**ORANGE COUNTY WATER DISTRICT**

Subject: Comment Letter – Mobil #18-HDR Case Closure Summary

**Subject: Review of Mobil 18HDR Recommendation for Closure**  
**OCWD v Unocal Corp., et al. (No. Civ. 4968)**  
**OCWD Agreement No, 0884, Aquilologic Project Number 002-02**

**Attachment 2, Page 8, Most Recent Concentrations of Petroleum Constituents in Groundwater**

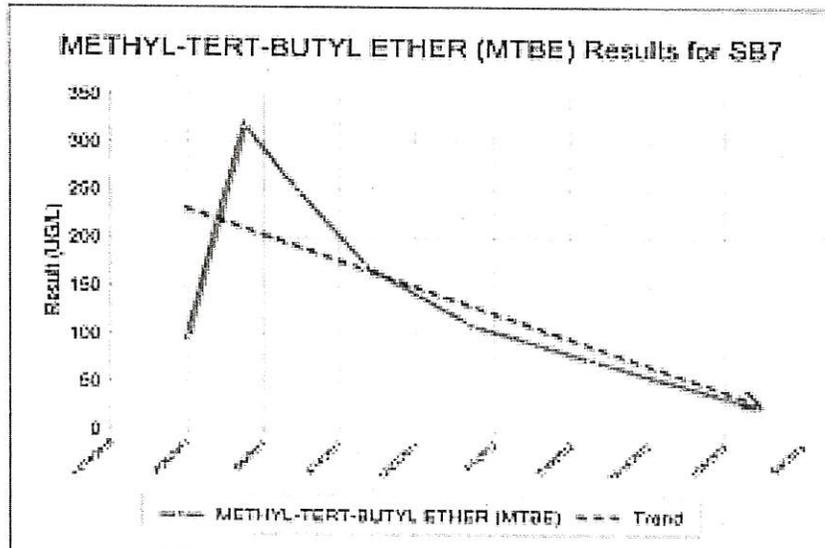
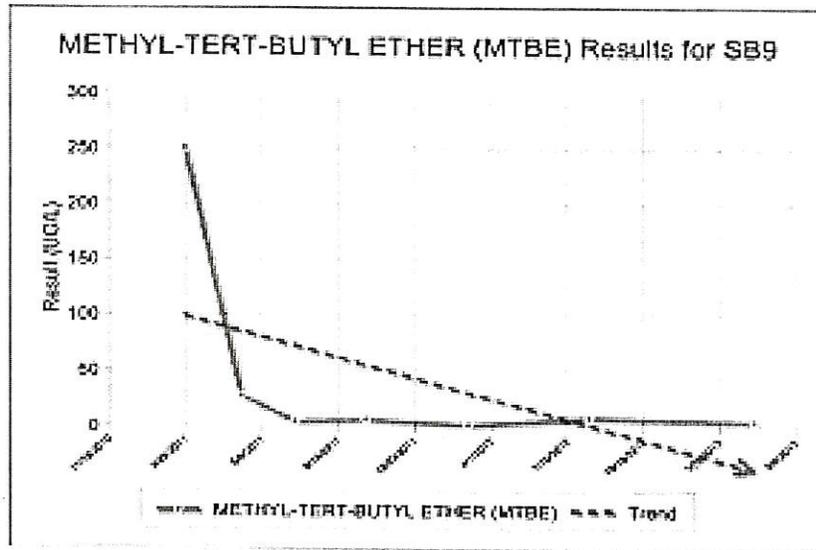
**Response:** The summary table of the most recent concentrations of petroleum constituents in groundwater does not include the results of depth discrete groundwater samples collected on

behalf of ExxonMobil in 2009 (ETIC, 2009a). As part of an off-site assessment, ExxonMobil completed three discrete-depth temporary groundwater monitoring wells approximately 500 feet to 600 feet down-gradient of the Mobil 18HDR site. The maximum concentrations of benzene, MTBE, and TBA reported in samples collected from these discrete-depth sampling points were 6.2 ug/l (SB4), 760 ug/l (SB4 and SB6), and 1,600 ug/l (SB4), respectively (ETIC, 2009a). All of the maximum concentrations reported for each contaminant were greater than their respective WQO's. Additionally, the maximum reported concentrations for benzene and MTBE exceeded their respective MCLs. Each of these discrete-depth sampling locations are located up-gradient of the furthest down-gradient monitoring wells and the reported concentrations are greater than ever detected in the down-gradient monitoring wells. It is expected that as contaminant migration continues down-gradient, the concentration of contaminants in the down-gradient monitoring wells will increase.

Additionally, between 2011 and 2012, the OCWD collected a number of discrete depth groundwater samples down-gradient of the Mobil 18HDR site (aquilogic 2013). The maximum concentration of benzene, MTBE, and TBA reported in discrete-depth samples collected by the OCWD down-gradient of the Mobil 18HDR site were 47 ug/l, 1,400 ug/l, and 320 ug/l, respectively (Table 1). The SWRCB defined WQO for MTBE (5 ug/l) was exceeded in a contiguous plume extending a distance of more than 5,000 feet down-gradient of the Mobil 18HDR site (Figure 1).
